City of Biddeford
Planning Board
July 01, 2020 6:00 PM Via ZOOM

Planning Board MINUTES (DRAFT)

PLANNING BOARD REPORT

PLANNING BOARD REPORT

SECOND FINAL
AMENDED PLAN
CATHEDRAL OAKS PHASE III
CATHEDRAL OAKS DRIVE
BIDDEFORD, MAINE

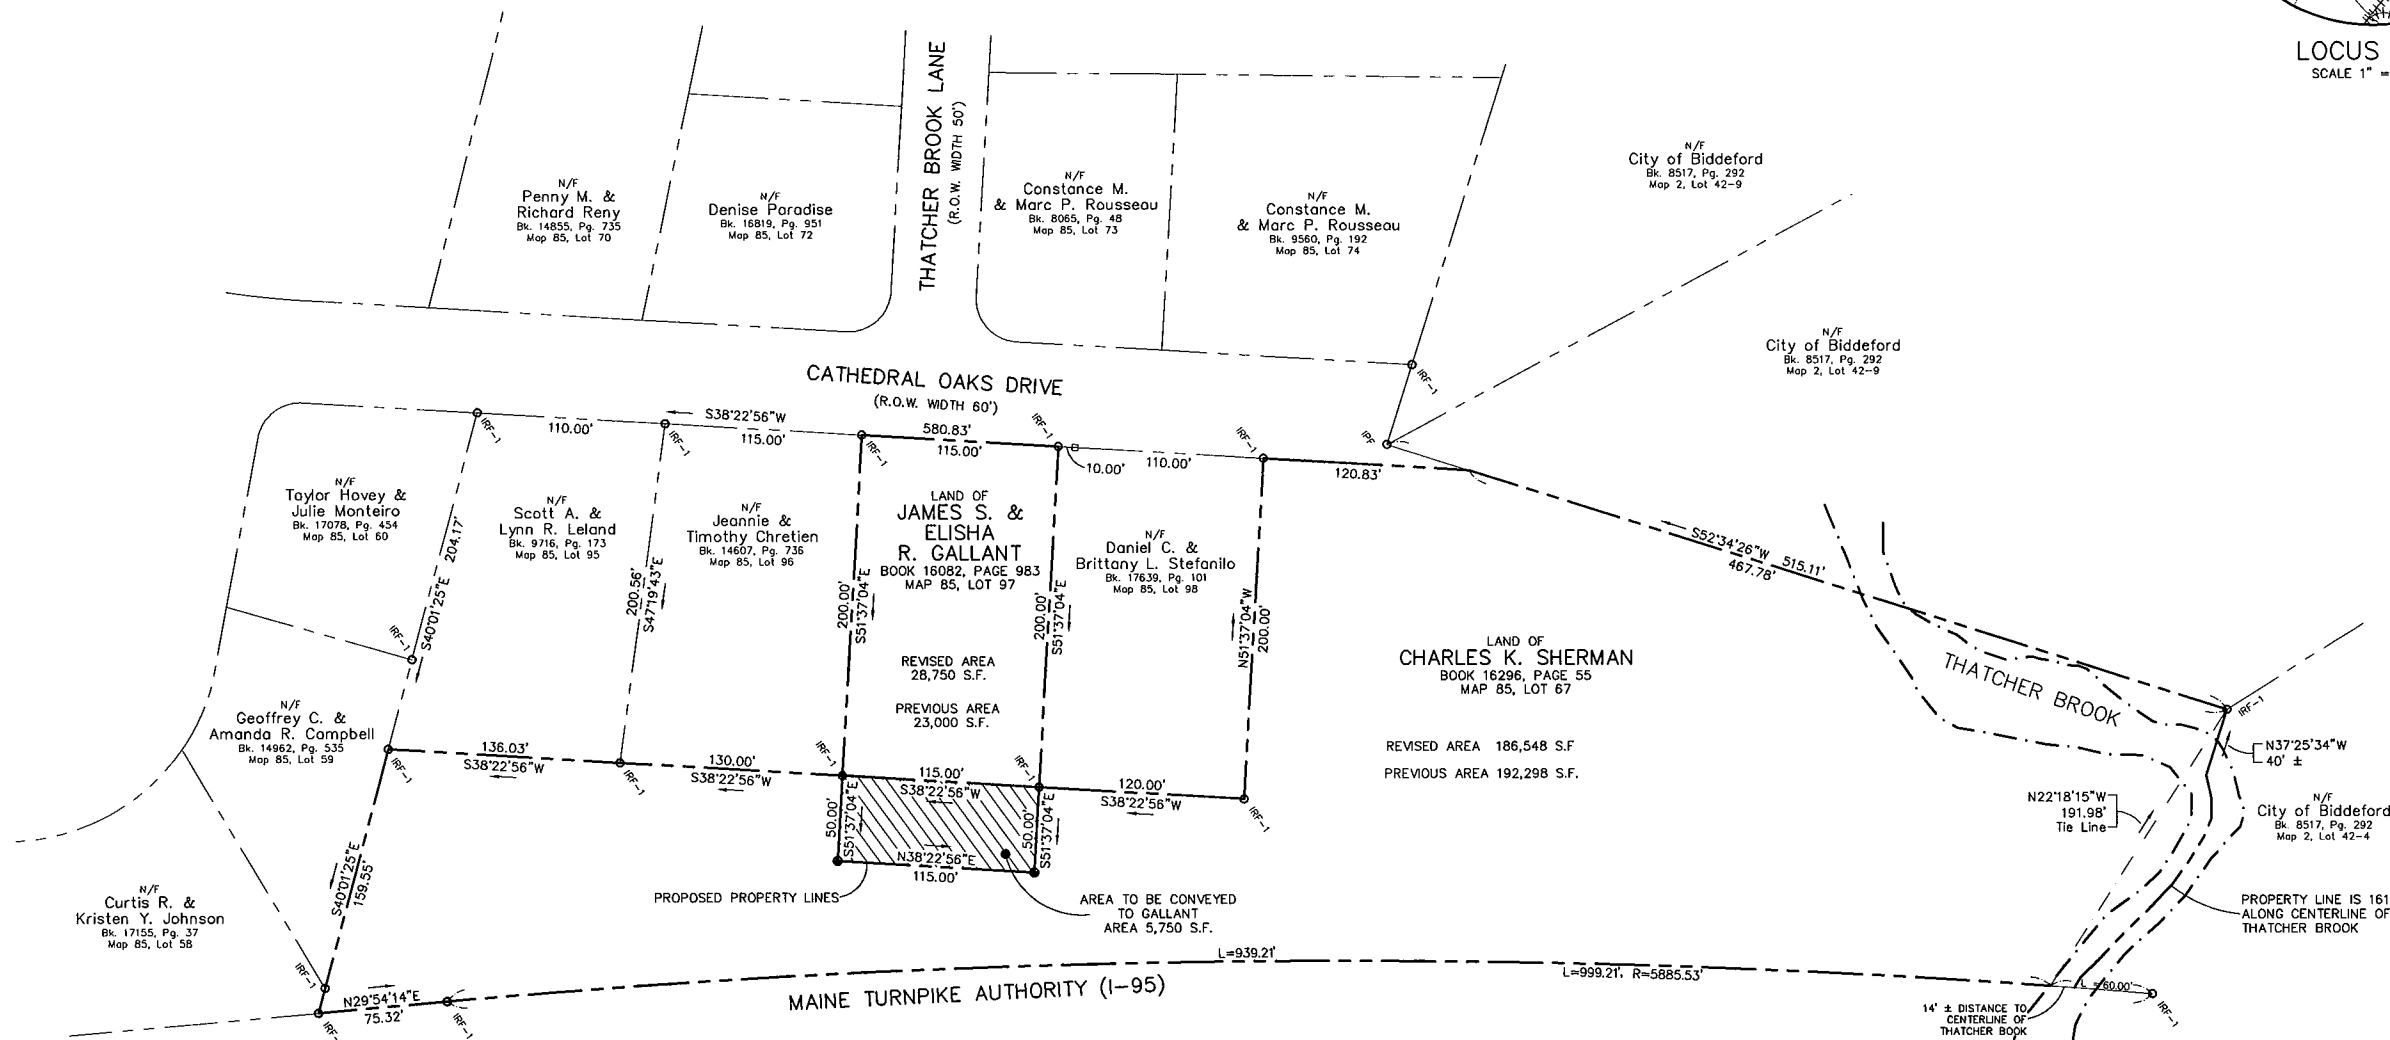
- 1. Provide evidence that Mr. Gallant authorizes the application. The application is only signed by Mr. Thompson with no authorization letter from either land owners.
- 2. Provide evidence that Mr. Sherman authorizes the application. The application is only signed by Mr. Thompson with no authorization letter from either land owners.
- 3. Add a Signature Block on Final Plan.
- 4. Add underneath the Signature Block the following:

5. Add a Note to Sheet 1 as follows:

“Due to the coronavirus pandemic and the Governor’s declaration of a civil state of emergency and a statewide stay at home order, the Planning Board pursuant to Chapter 66-9 authorized the City Planner to sign the final plan on behalf of the Planning Board and declared that the final plan once signed by the City Planner shall be deemed to have been signed by individual members of the Planning Board evidencing approval of the final plan.”
